**PCN/21/035/C+N-US**

**Product Range:** Han Q

**Title:** Modification Han® Q4/2

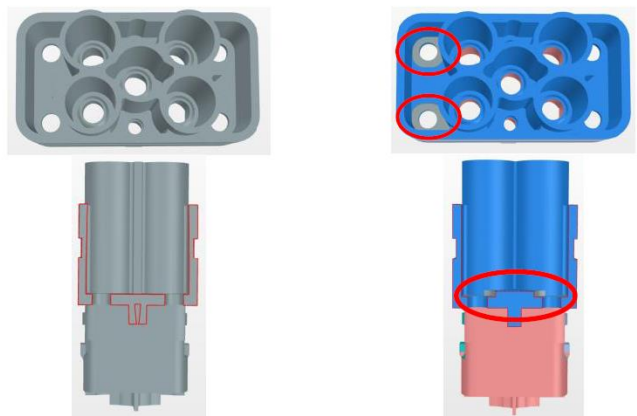
<b>1. Concerned Part Numbers</b>
09 12 006 3041
<b>2. Description of Changes/News</b>
<p>Thickening of the base plate due to optimization of the manufacturing process.          No design change for the area of the fixing screws.</p> <div style="text-align: center;">  <div style="display: flex; justify-content: space-around; width: 100%;"> <div style="text-align: center;"> <p>Old version</p> </div> <div style="text-align: center;"> <p>New version</p> </div> </div> </div>
<b>3. Impact on Product Specification</b>
No influence on the product characteristics.
<b>4. Scheduled Date of Implementation</b>
07/31/2022
<b>5. Identification of Change</b>
New revision level
